DEAB – Mixed Use Design Standards

Clark County Code Mixed Use Design Standards

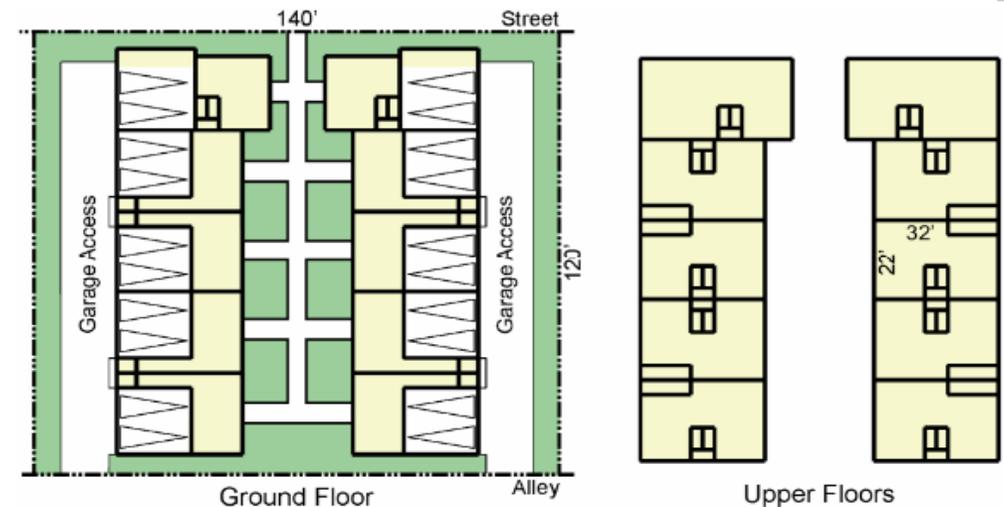
- Townhome standards were written assuming they are multi-family, not fee-simple townhomes. Staff has interpreted that fee-simple townhomes are subject to Section G, Single-Family/Duplex Developments, yet Section G isn't listed as a Key Applicable Standard under the townhome housing type.

Figure D-16. Corner building treatments.

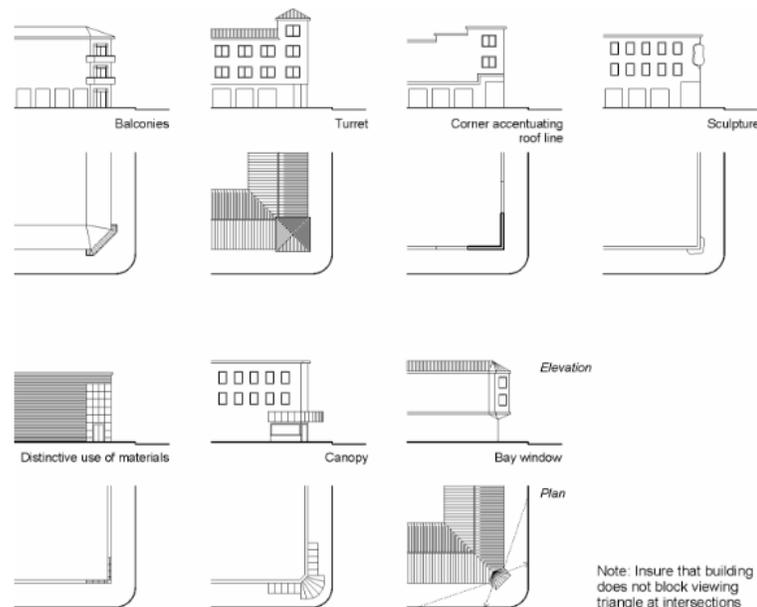
- Requirements are excessive and should not be required for fee-simple townhomes. Duplexes and detached single-family housing are not subject to Chapter D.

Figure E-6. Trash receptacle screening example.

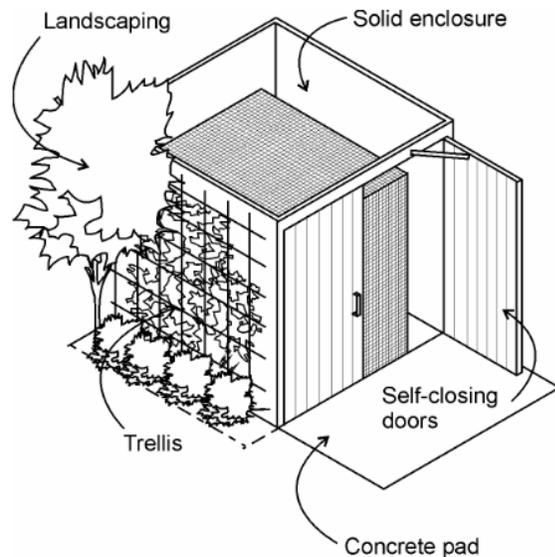
- Should not apply to solid waste enclosures, which are required to be 6-feet tall.

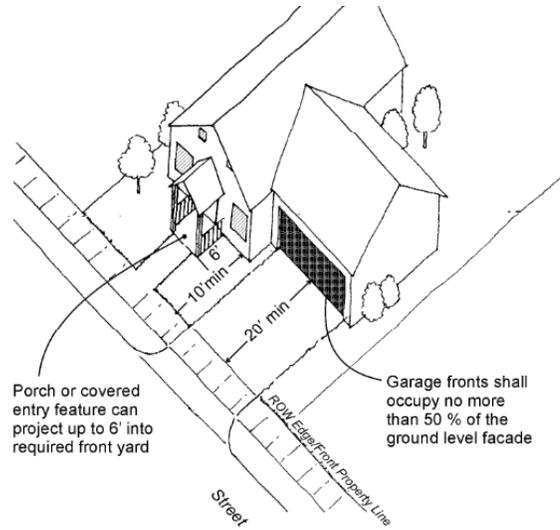
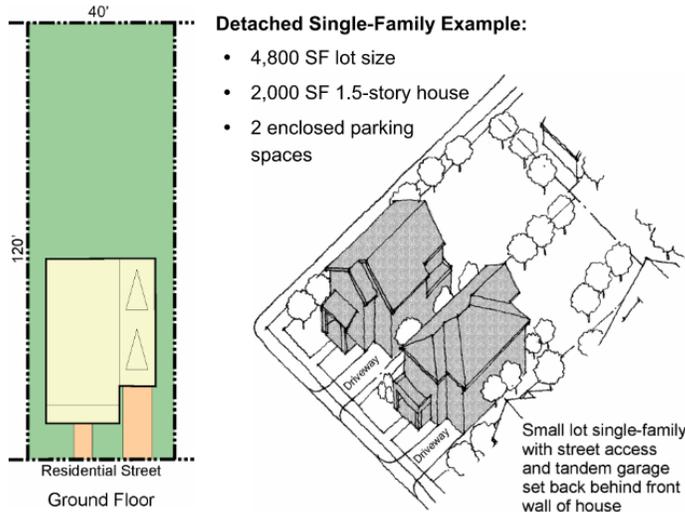
- A maximum FAR seems to contradict the intent of higher density in mixed-use developments.
- Should not apply to fee-simple townhomes. A maximum of 0.50 FAR is impracticable to meet with townhome lots, without unnecessarily deep lots.
- Permitting staff has been interpreting Gross Floor Area to include garages. The Standard should specifically exclude garages from calculation so there is no interpretation required at the building permit level.

Figure G-5. Illustration of driveway standards.

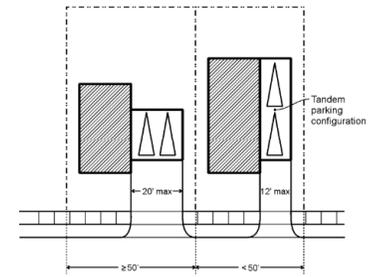
- Should allow a second driveway for an ADU if the two driveways enter separate streets (corner lots) like duplexes are allowed.
- Driveway width restrictions should not apply to driveways accessing from an alley. Historically staff has interpreted this to only apply to streets, not alleys.

Figure G-4. Design standards for garages.

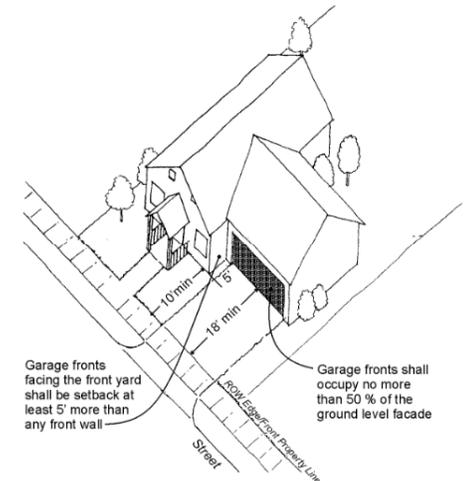
- Should allow a reduced setback on upper floors of multi-story homes. A five-foot second story cantilever is an expensive design requirement and results with the garage being in a hole. A 2–3-foot setback and second story overhang would still meet the intent of deemphasizing the garage face while reducing housing costs.
